**MUNICIPAL SERVICES CENTER, COUNCIL CHAMBER
3600 TREMONT ROAD**

BZAP Meeting Date: Wednesday, April 5th, 2023

Subject: Work Session review of revisions to Variance 05-23

Property Owner/Address: Saliaris, 2712 Swansea Road (zoned R-1c)

PROPOSED SITE PLAN

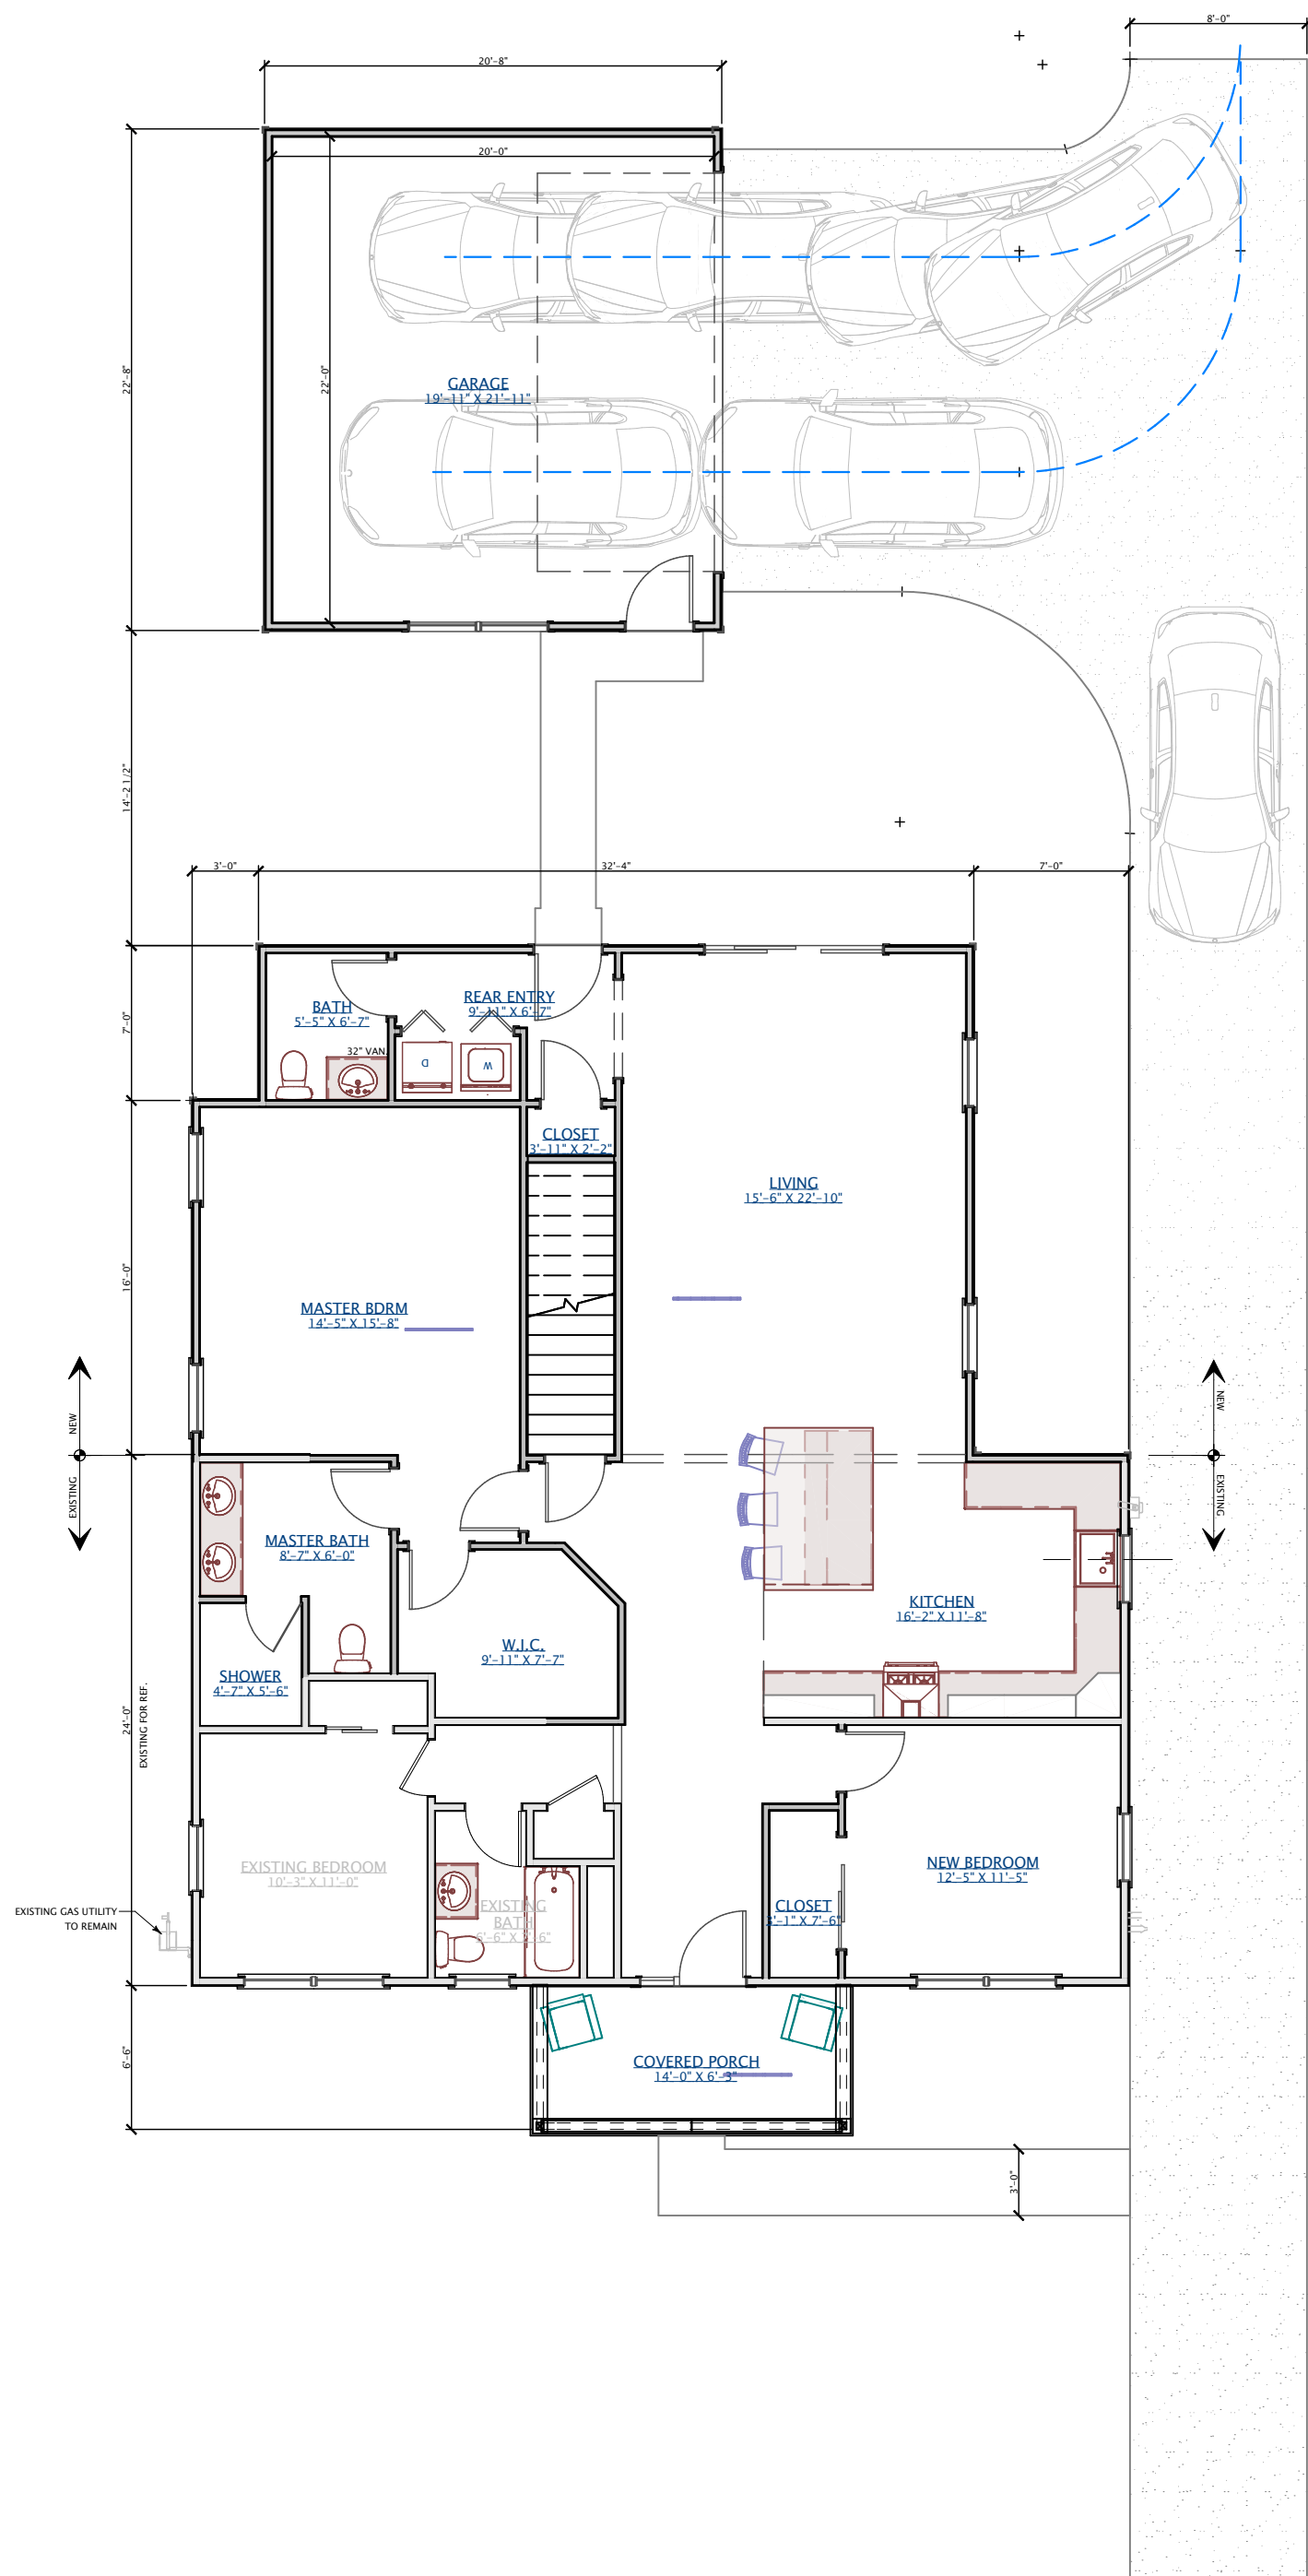
Since that time, the detached garage has been reduced in size from 531 square feet to 466 square feet, a 65 SF reduction. No other changes have occurred. After a review of Article 6.01 relating to yard projections, Staff has determined that a variance is not needed for the proposed front porch, as its roof overhang projects less than eight inches into the front setback.

- To UDO Article 5.02(C) to permit an addition that encroaches up to 1.2 inches into the 8-foot minimum side yard setback; and
- To UDO Article 5.02(C) to permit improvements that result in building cover of ~~30.8~~ 30 percent, when 29 percent is the limit.
- ~~To UDO Article 6.01(D) to permit a front porch to encroach 14' 2" by 7 inches into the front yard setback, when a maximum of 10 foot by 5 foot projection is permitted.~~

2712 Swansea Road

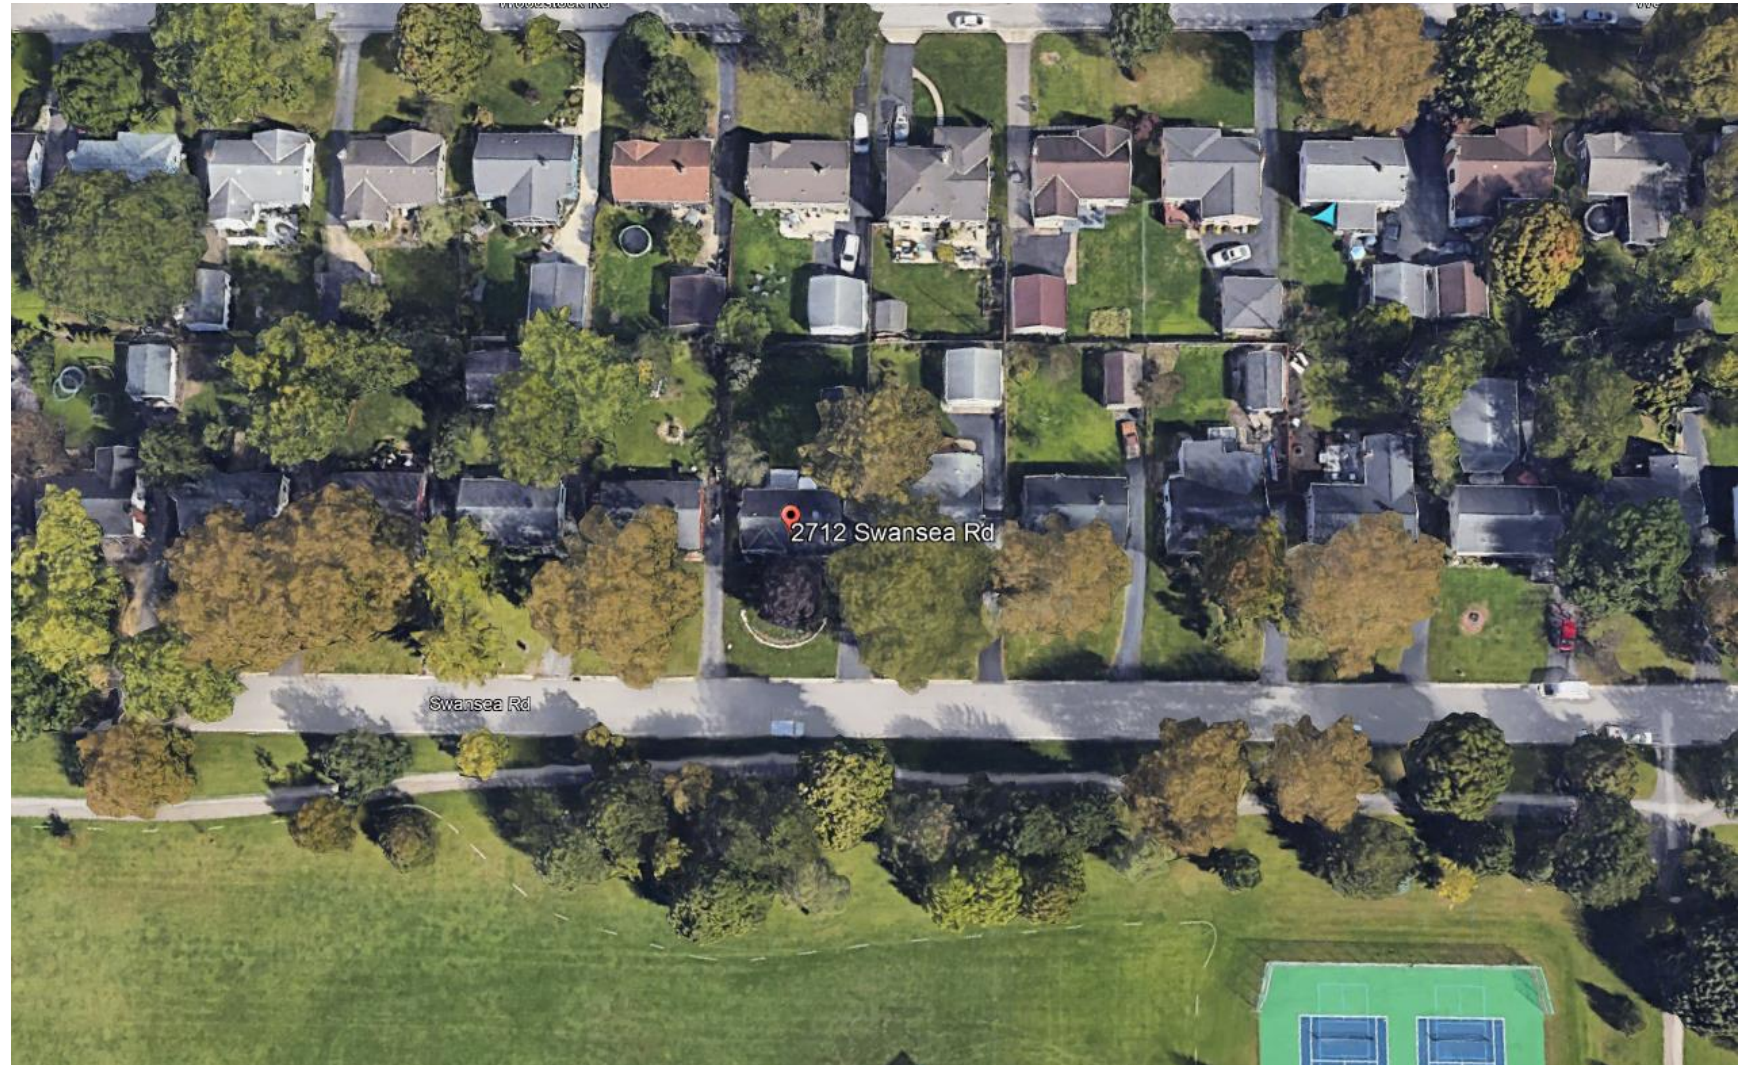
The homeowner is proposing multiple improvements to the property including a new front porch, rear addition, and two-car garage, which has resulted in three variances requested. The front porch would be 14 feet by 6'-3", and encroach just seven inches into the platted front yard setback. The porch has a gable roof and wood columns and beams. Front facade improvements to the home are also planned for this project, including the addition of a stacked stone water table and vertical fiber cement panels.

Alternatives to the current plan include relocating the addition 1.2 inches away from the side property line. This would meet the setback requirement, but would offset the addition from the existing home. The front porch could also be reduced in depth (by 7 inches) or width (by 4 feet), in order to meet the maximum projection allowed of 10 feet by 5 feet. Finally, the overall building improvements could be reduced by 146.25 square feet, which would meet the 29 percent building cover limit. Alternatively, a second-story addition could be considered, in lieu of the first floor addition.

Staff cannot recommend approval of the application as submitted and would encourage the homeowner to review alternative options that reduce and/or eliminate variances for the proposal. Should the Board choose to approve the request, Staff would recommend requiring a landscape plan to help soften views of the addition from neighbors. This could be reviewed and approved by the City Forester with the Building Permit. The Board may consider Findings #3 and #6 during review.

DATE
29 MARCH 2023
DRAWING
**LANDSCAPE
/SITE PLAN**
SHEET NUMBER
A1-0
JLB PROJECT #22012

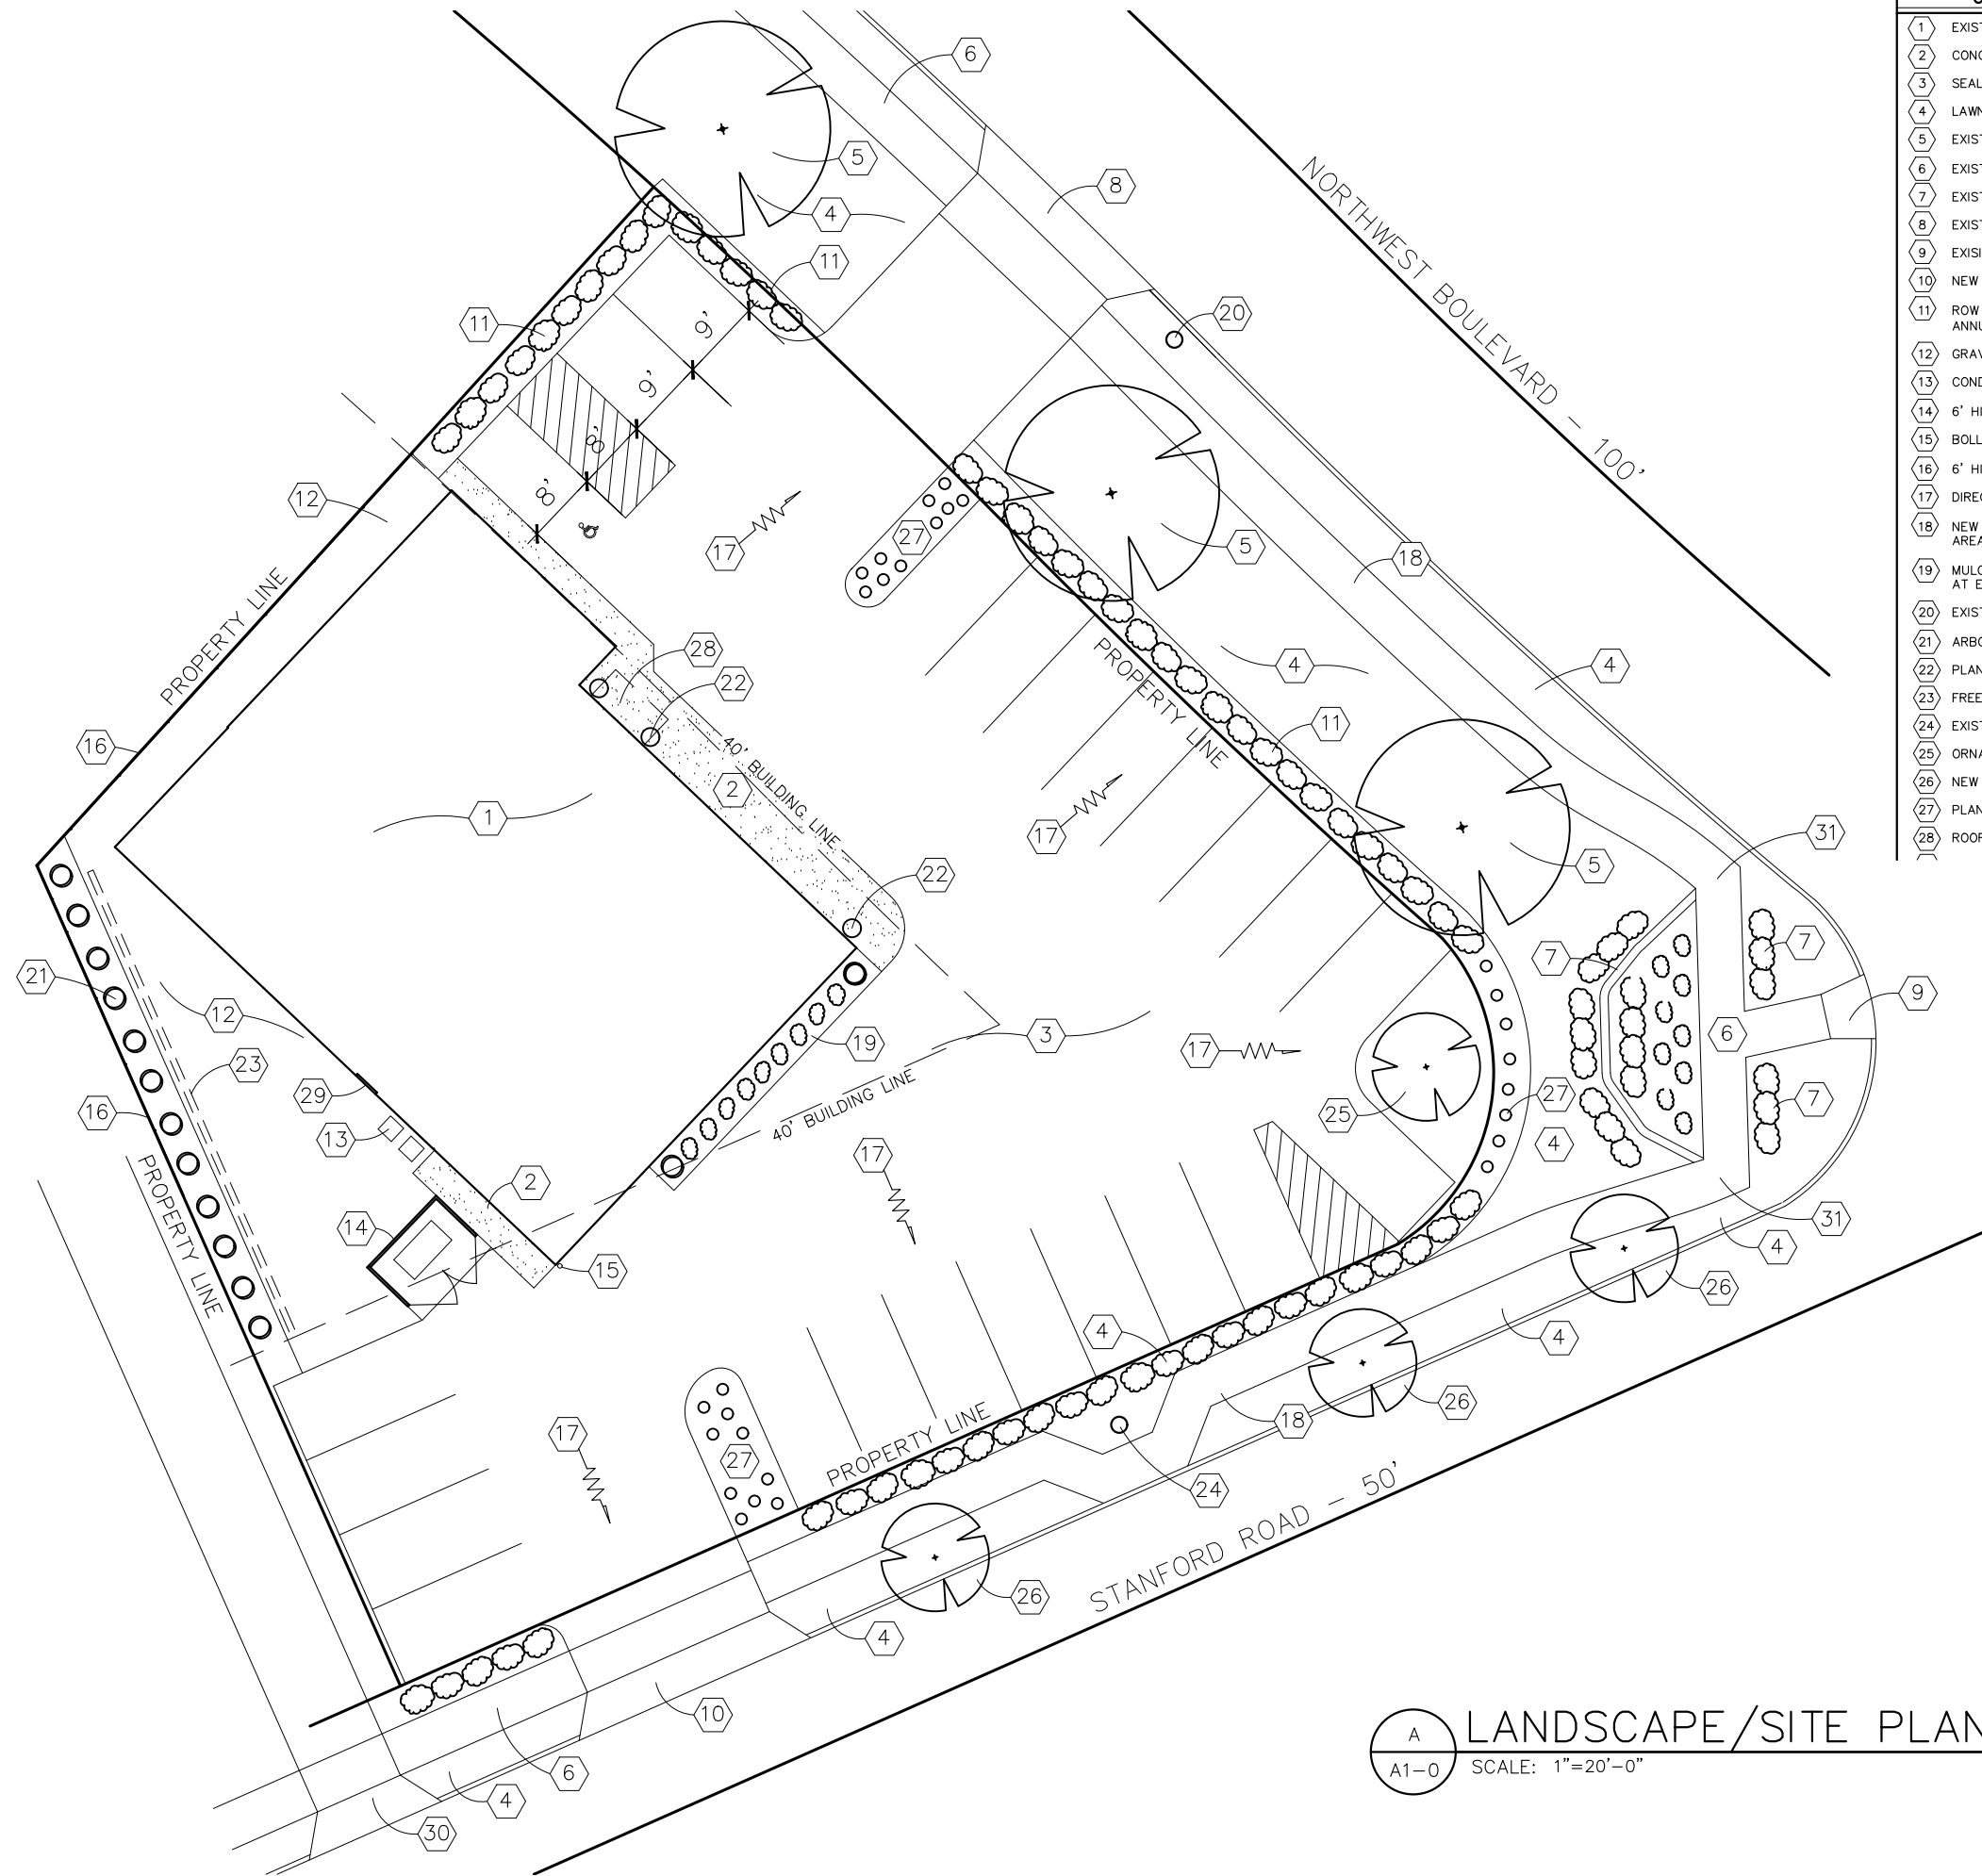
A landscape plan has been submitted and reviewed by the City Forester; it includes foundation plantings, parking lot screening and street trees; minor adjustments are needed, and Staff is scheduled to meet on-site with the applicant prior to the Work Session to collaborate.
